**ASHLAND PLANNING DEPARTMENT
PRE-APPLICATION CONFERENCE
COMMENT SHEET**
November 19, 2025

SITE: Map O4CC TL12100
APPLICANT: Sherrell
REQUEST: Site Design Review &
Land Partition

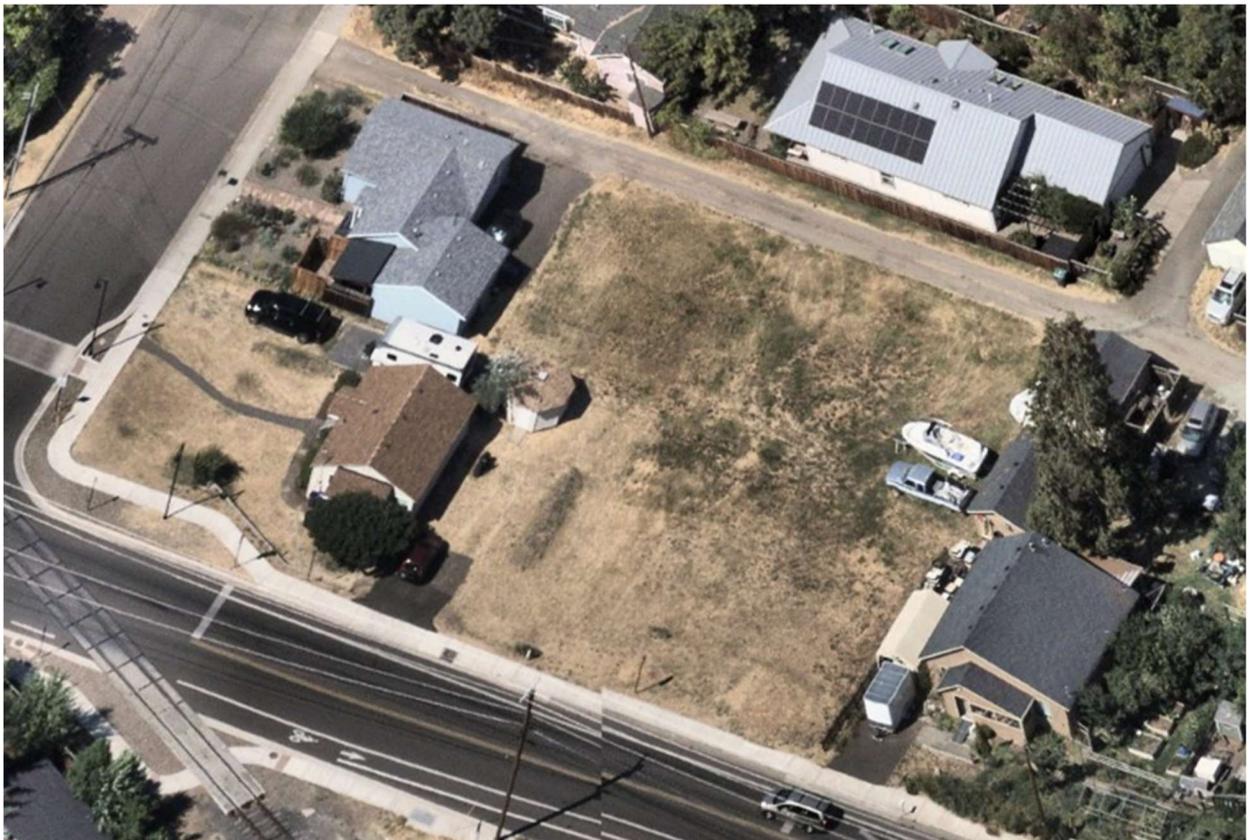
Alley Access/Hersey St SAE: It is unclear whether the Shared Access Easement illustrated between Hersey and the alley is intended as vehicular or pedestrian access. AMC 18.4.3.080.C.4.c does not allow vehicular street access where alley access is available; a driveway from Hersey Street would require a Variance. The alley would need to be paved from Laurel to the eastern boundary of the property as the site's vehicular access, and it would be advisable to consider the paving and building placement with emergency vehicle, two way vehicle circulation, and delivery access in mind.

Parking: The final application will need to demonstrate that voluntarily provided off-street parking, required ADA-accessible parking and required bicycle parking are provided in a manner consistent with standards, including that adequate back-up area is provided. For spaces backing to the alley, from the parking spaces to the opposite side of the alley improvements would need to be 22 feet (*i.e. a total of 40 feet from front of space to opposite side of alley for standard spaces, or 38 feet for compact spaces*). If only one ADA space is to be provided, there would need to be access easements to allow shared use by all parcels.

Vehicle Area Design: Parking areas of more than seven spaces are required to be designed to minimize environmental and microclimatic impacts through design and material selection as detailed in AMC 18.4.3.080. Of particular note, parking lots and other hard surfaces are required to be designed to capture and treat stormwater run-off with landscaped medians and swales. All new parking lots are required to meet state Climate Friendly & Equitable Communities standards including at least one parking lot tree per seven parking spaces, canopy coverage of at least 30 percent of the parking area, and demonstration of compliance with ANSI 300 standards for parking lot trees.

Required Buffers: Parking Lot Landscaping and Screening requirements in AMC 18.4 require a minimum five-foot width buffer between parking lots/driveways and property lines.
